**ON-SITE SEWAGE DISPOSAL SYSTEM  
 HOWARD COUNTY HEALTH DEPARTMENT  
 BUREAU OF ENVIRONMENTAL HEALTH**

SUBDIVISION: Edgewood Farms LOT NUMBER: 60

ADDRESS: 14516 Edgewoods Way PROPERTY OWNER: Toll MD V LP

WALLCHECK  
 LOT #60  
**EDGEWOOD FARM**  
 LIBER 4174, FOLIO 0436  
 PLAT No. 19266, et seq  
 FOURTH ELECTION DISTRICT  
 HOWARD COUNTY, MARYLAND

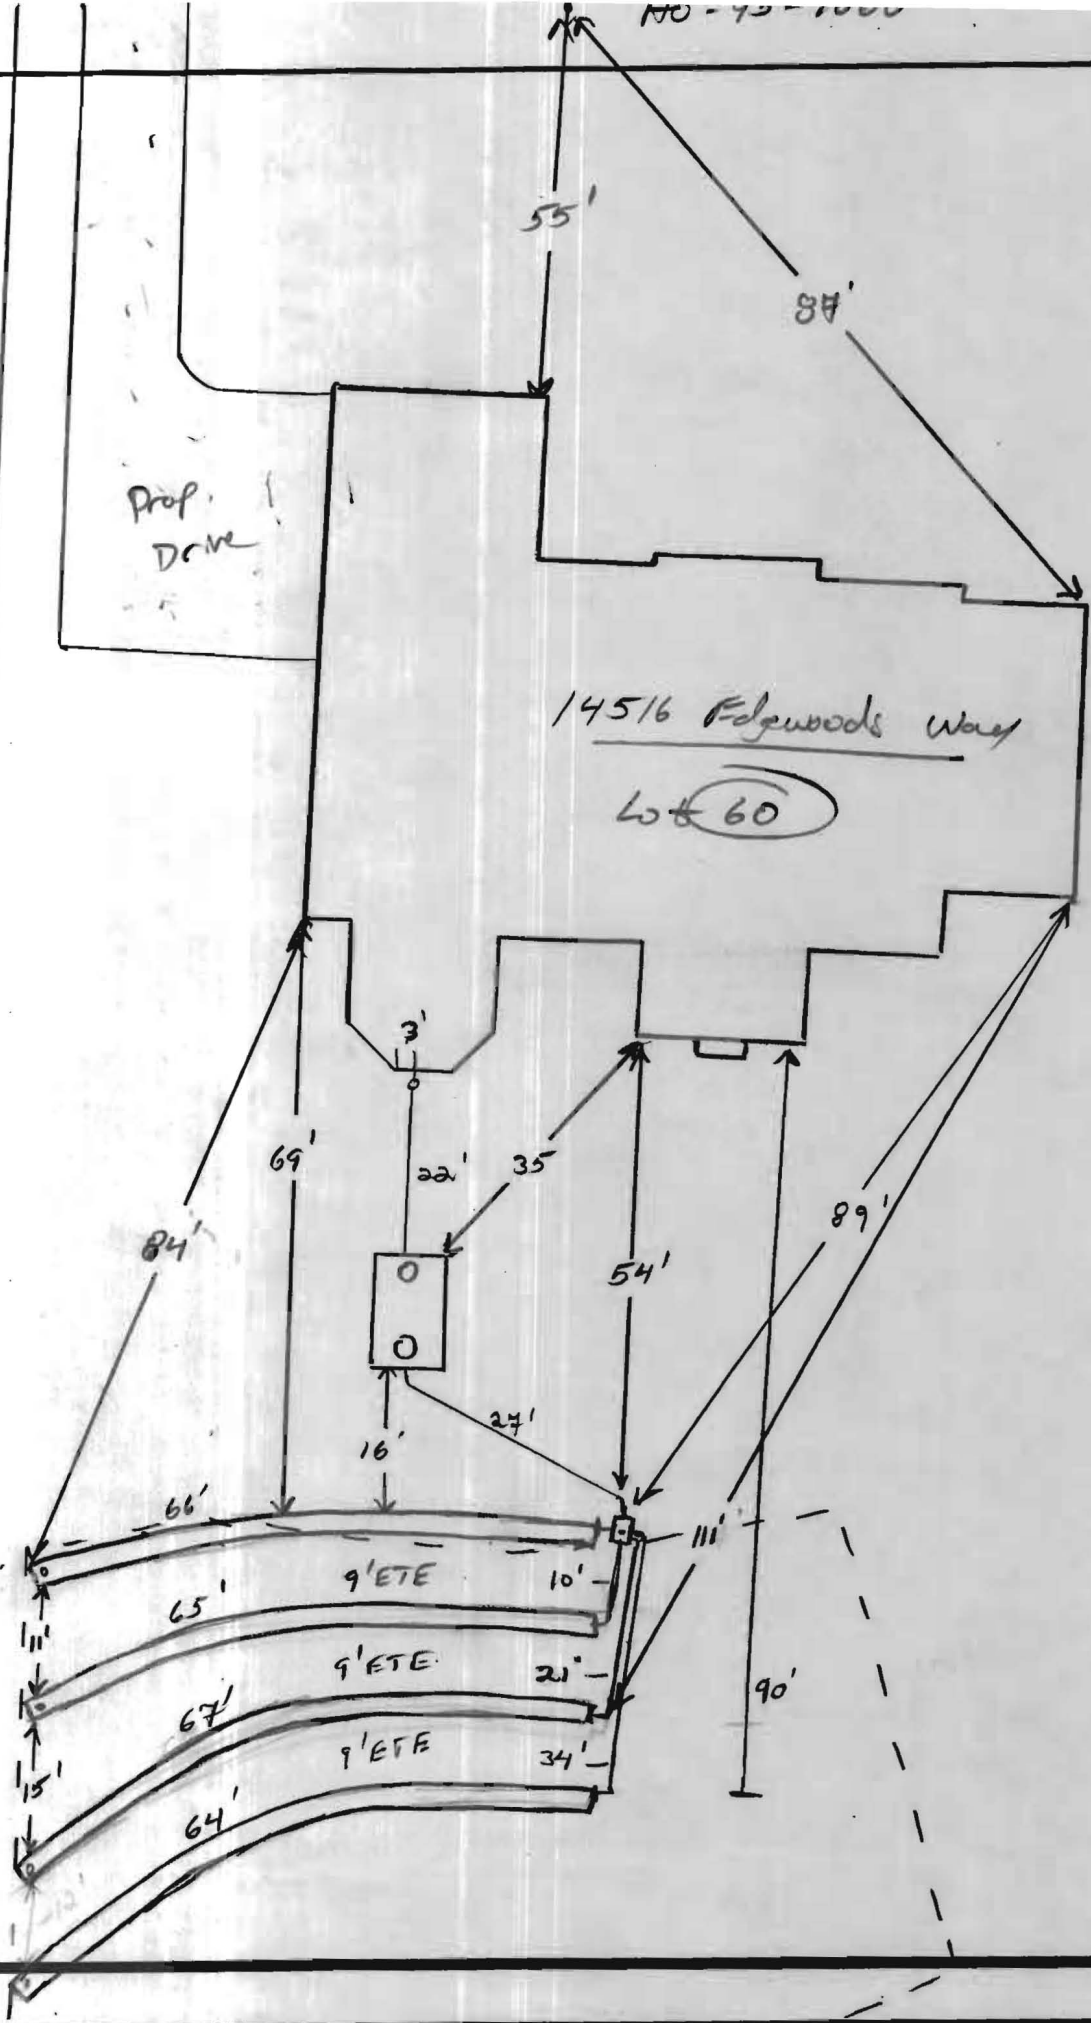
2/3/09 Perc test hole dug to confirm inaccurate soil perc during testing. 3' restriction. Typical swell soil (see iron

depletions w/ clay clays on pad's B horizon -> C horizon). Keep 2' wide trenches, Inlet 3 bottom 4'. Run 4x65' trenches on contour towards

INSTALLATION: Lot 5. Pull 65' square from edge of S.D.A. Call for insp. 2/4/09 Tank and D box set per installation. Please correction made. No trenches installed. OK to continue (per) 2/5/09 System installed per plans. Trenches installed on contour. Ends of trenches taper out to adjust to contour. or large drainage swales. OK to bank fill (K)

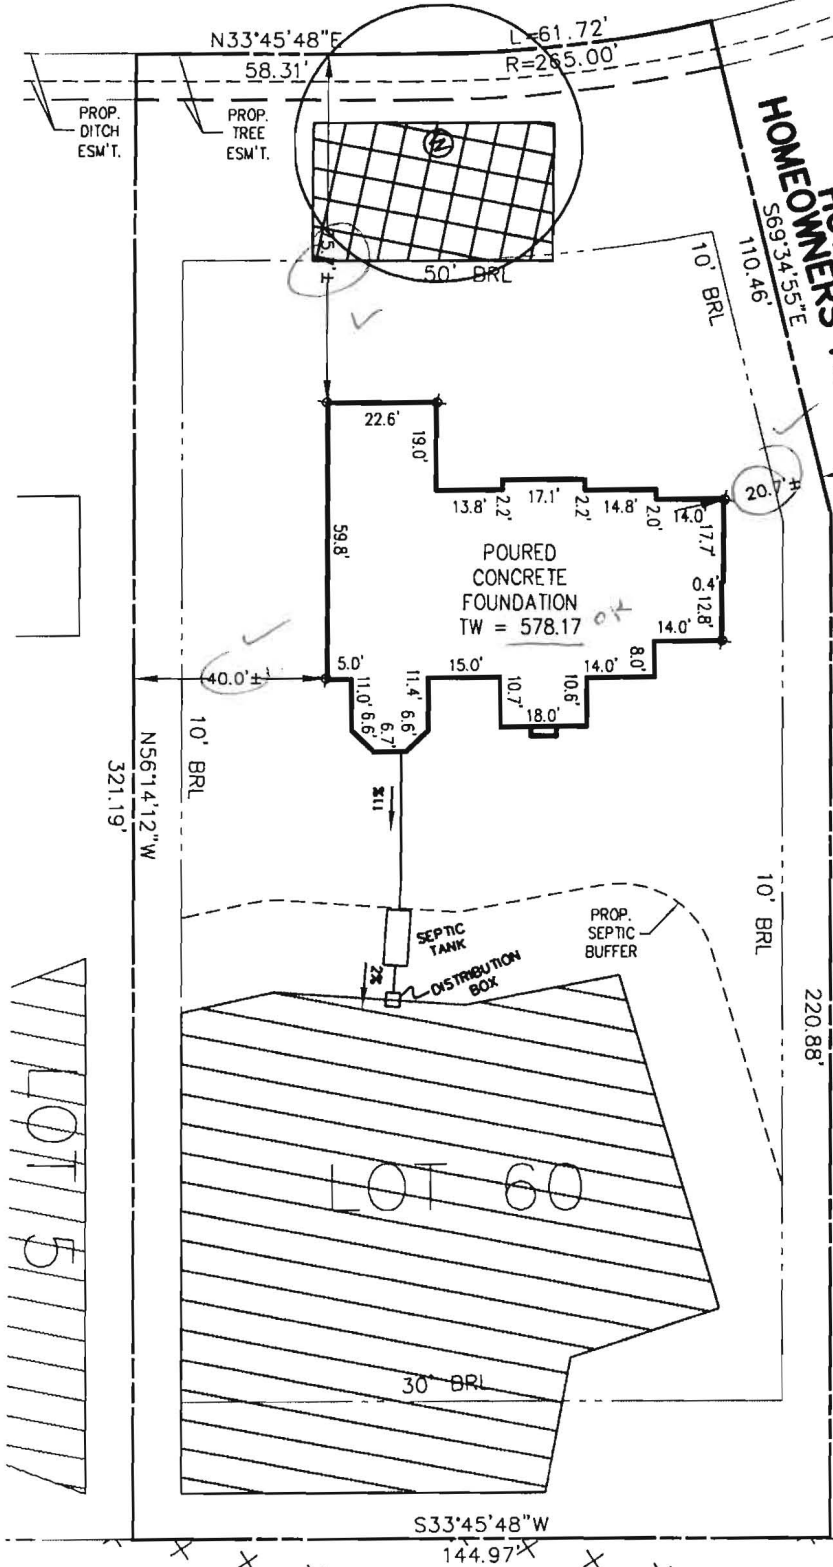
1/20/09  
 Well check OK  
 (KW)
